**U.S. NUCLEAR REGULATORY COMMISSION
Office of Nuclear Material Safety and Safeguards
Spent Fuel Project Office**

**CONFIRMATORY ACTION LETTER 97-7-001
TECHNICAL EVALUATION**

Docket No. 72-1007

Certificate Holder: Sierra Nuclear Corporation
One Victor Square
Scotts Valley, CA 95066

Figure A1

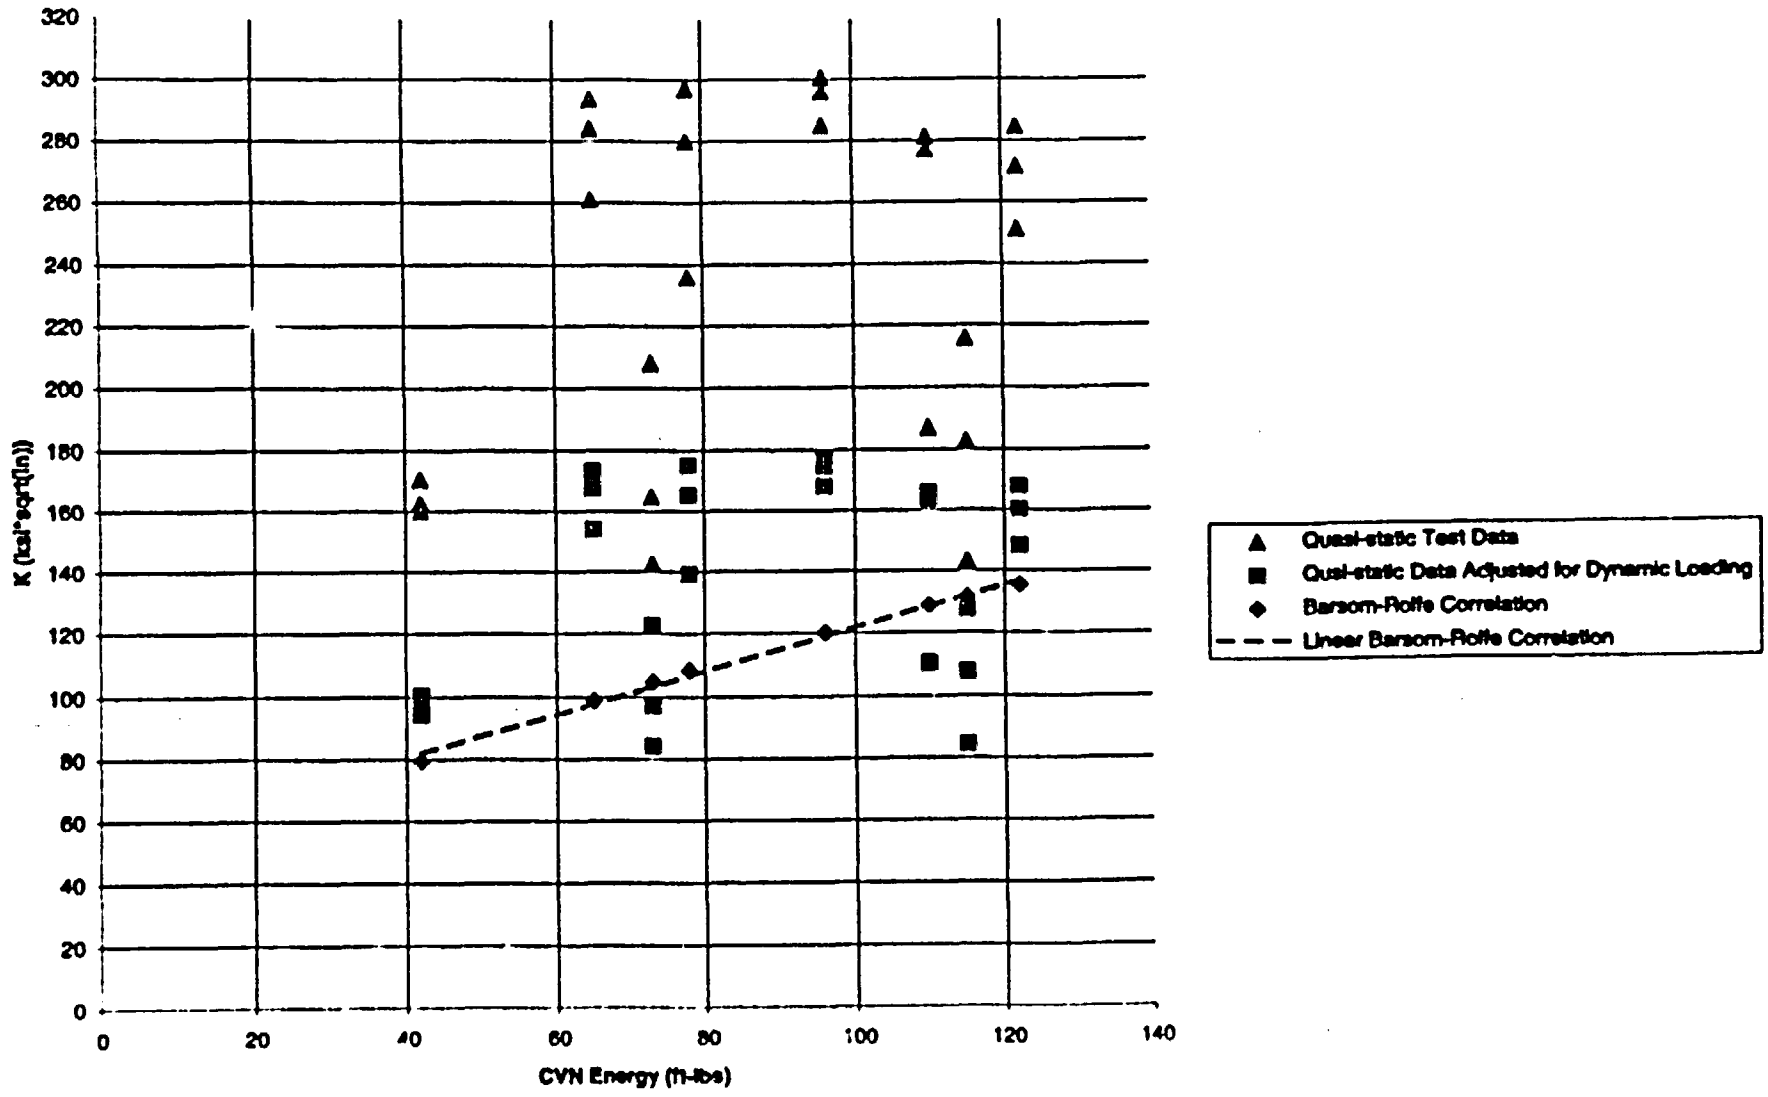
The staff plotted the data for fracture toughness and CVN provided by the Owners Group (Figure A1). The staff did not observe any relationship between K_{Ic} and CVN in the data presented and concluded that the Barsom-Rolfe correlation for the MSB material was inappropriate. This staff position was documented in the May 21, 1998, letter from NRC to SNC.

In its independent evaluation, the NRC staff considered fracture toughness data generated by both the Owners Group and NSWC and used the following approach to arrive at a limiting fracture toughness of 53 ksi \sqrt in for a temperature of 0°F:

Figure B1

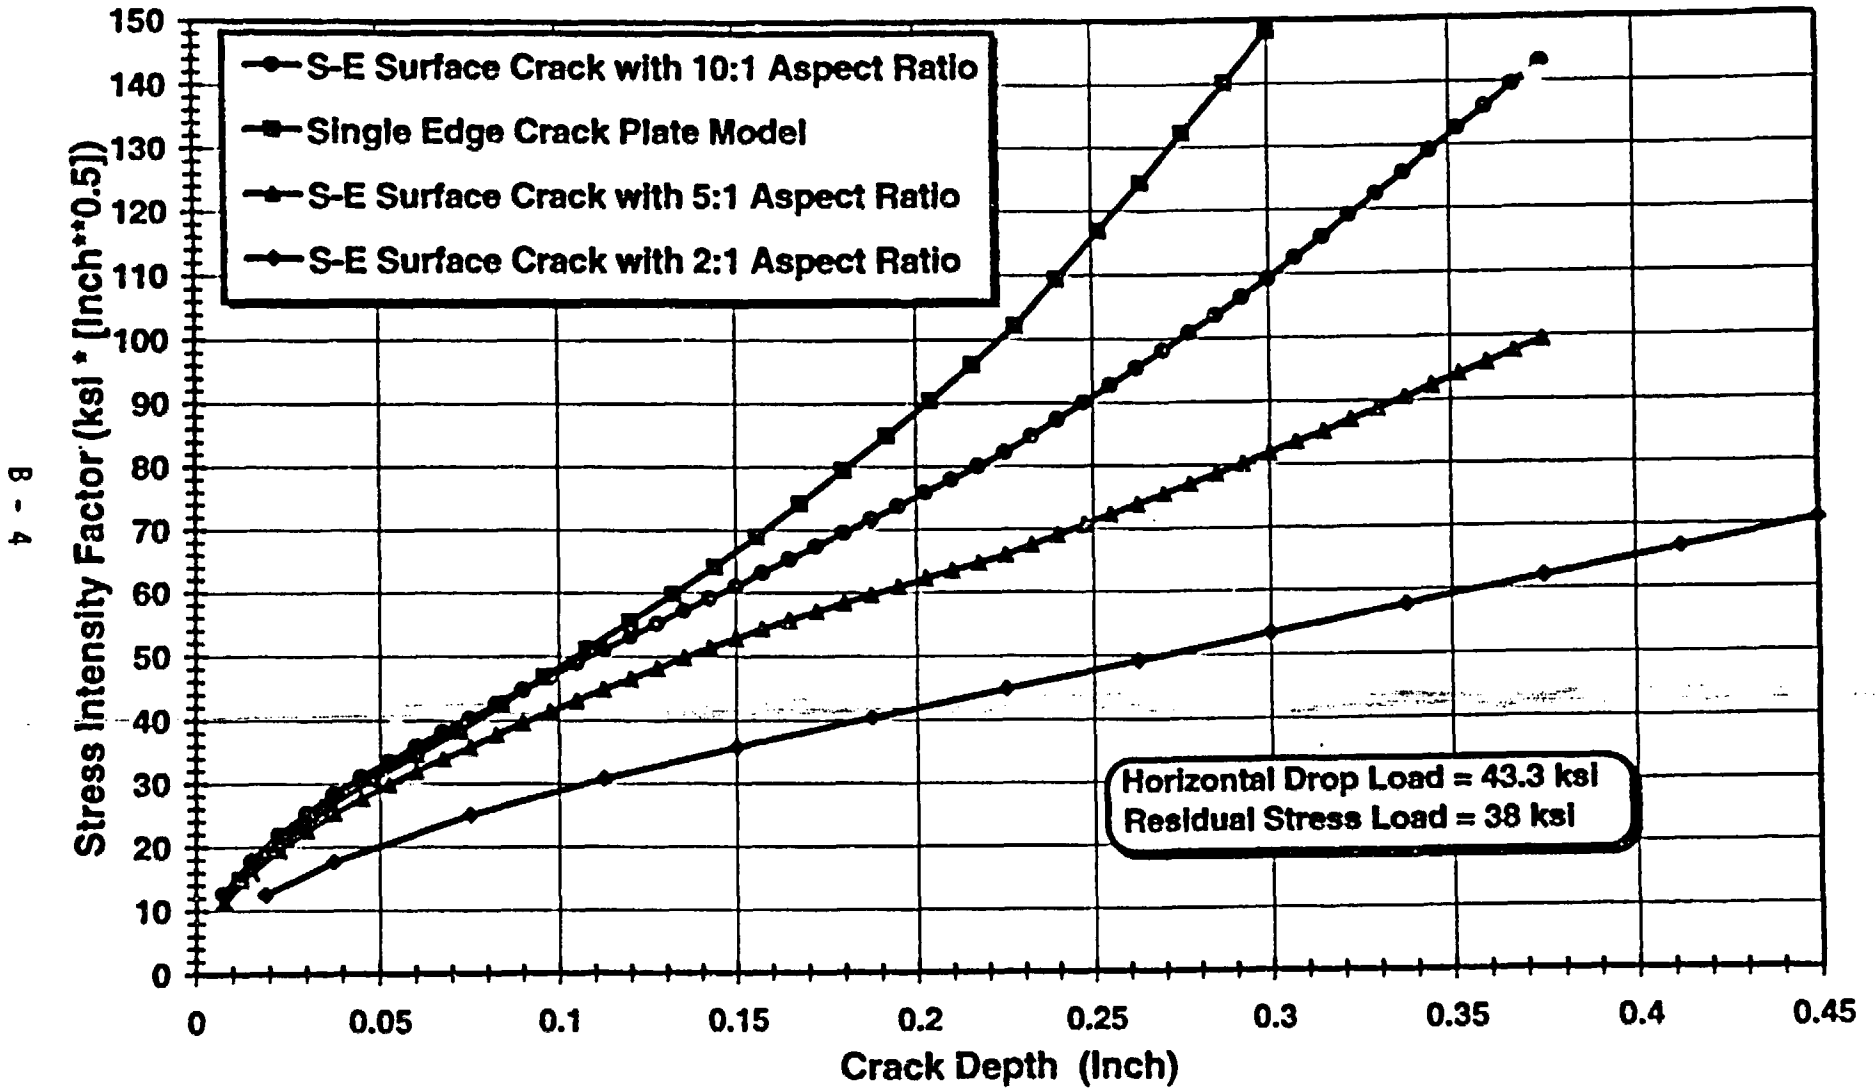
Figure B1 shows the maximum stress intensity factors (K_I) for the semi-elliptical cracks with aspect ratios, a/c , of 0.5, 0.2, 0.1 and 0 SECP, as a function of the crack depth. It can be seen that as the aspect ratio, a/c , value decreases from 0.5 to 0, the crack driving force (K_I) values increase with the SECP (i.e., for $a/c = 0$) being the highest value for any given crack depth.
